MOTOR COACH INDUSTRIES

Re: **NHTSA Campaign No. 06E-019**
Detroit Diesel Corp. Series 60 Turbocharger Failure

SUBJECT: DETROIT DIESEL SERIES 60 BURST LOGIC SAFETY RECALL

Subject: **Safety Recall 06C-4**
Series 60 Burst Logic

Baro Harness and Sensor

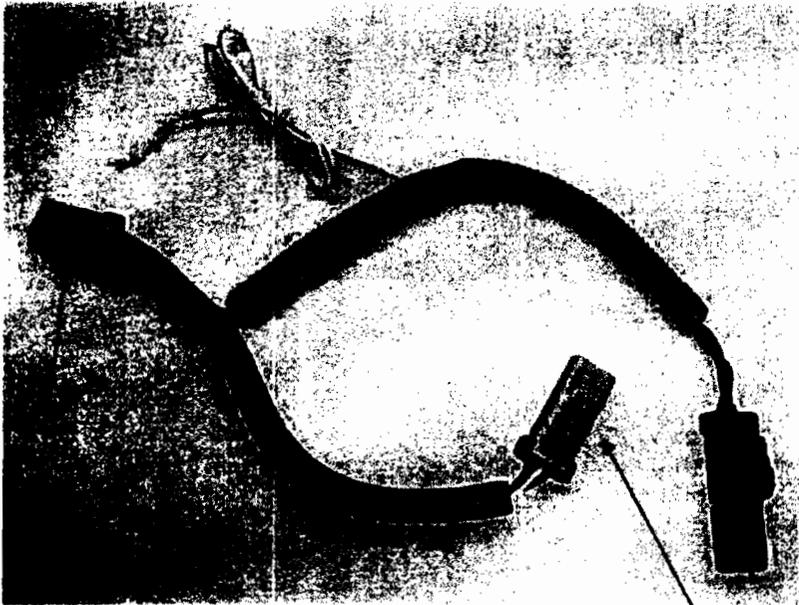
Connect to Turbo Boost Sensor

Connect to Sensor Harness Connector

Harness P/N 23536485

Sensor P/N 23527673

Installation of the barometric pressure harness and sensor.

This is a jumper (T) harness.

Unplug the turbo boost sensor and connect this harness in series with the existing sensor.

The loose length of wire needs to be installed in cavity L1 of the 30 pin sensor harness connector.

Remove 30 pin sensor harness connector from ecm.

Remove the cavity plug and install the new wire

Reconnect 30 pin to ecm.

Tie wrap the sensor to the engine sensor harness below the intake manifold.
